ONE NEW 2012 FORD F350 XLT DIESEL 4X4 DUALY CAB-CHASSIS or ONE NEW 2012 DODGE 3500 DIESEL 4X4 DUALY CAB-CHASSIS WITH AMBULANCE BOX REMOUNT

BID ADDENDUM #1

BID ADDENDUM #2

2012 MONO COUNTY AMBULANCE REMOUNT BOX PHOTOS

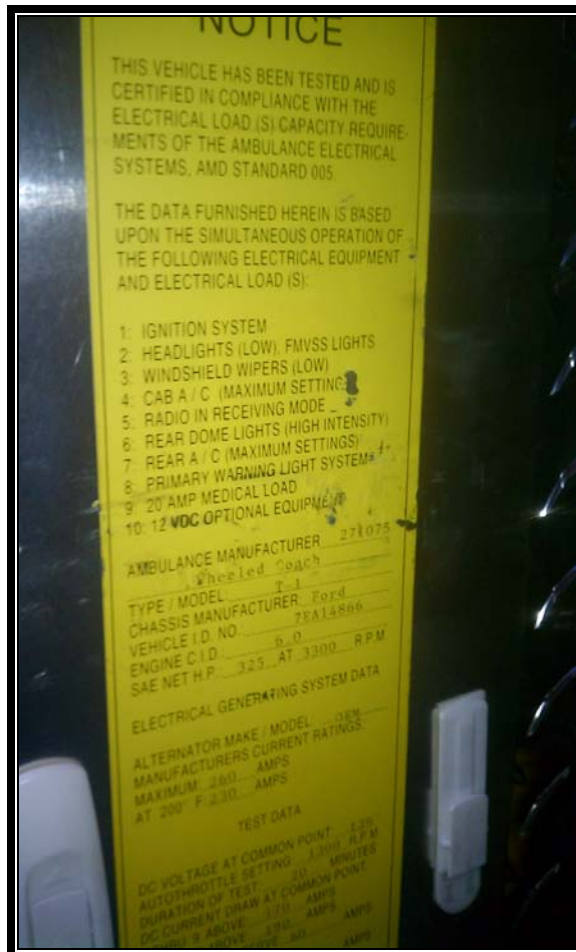
1. PAINT SCHEMATIC: This is to clarify the requested paint schematic. White cab with reflective red stripe. To match existing box and the remounted box is to be touched up as needed. Pictures attached for your reference.

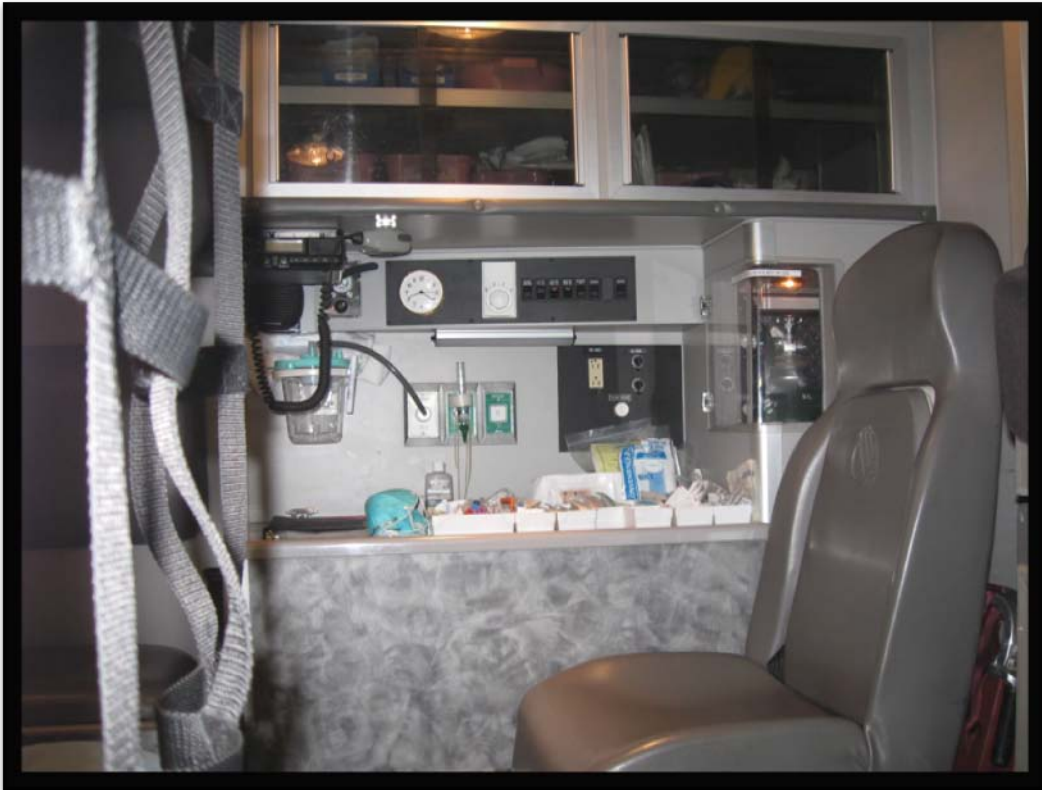
7. Flash light wiring: This is to clarify that the requested hard wiring is for a Stream lite – 12 volts flash light and is mounted on the inside of the first storage cabinet door on the passenger side just behind the cab door.

Desired console configuration for the 2012 Ambulance Remount

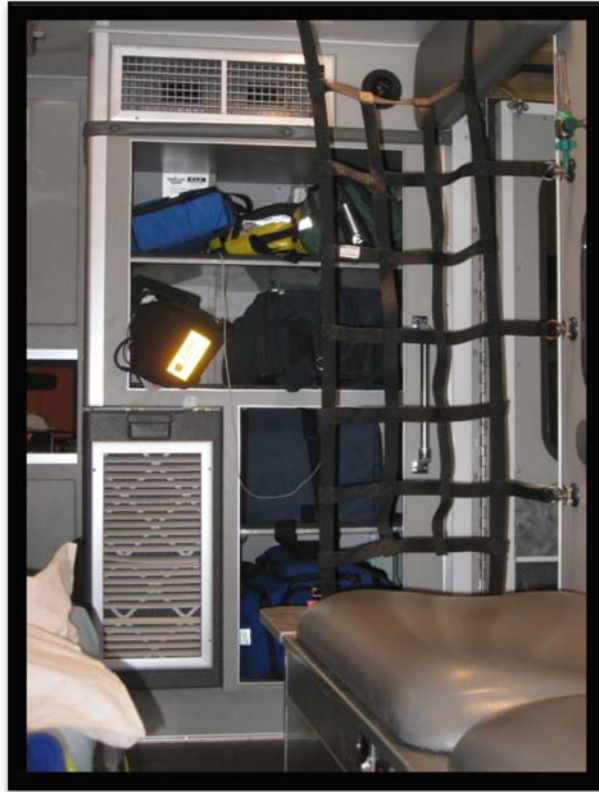
5. New center console: This is to clarify that an example photo of the desired console configuration is attached. Note: all electronic devises (radios & chargers) should be flush mounted.
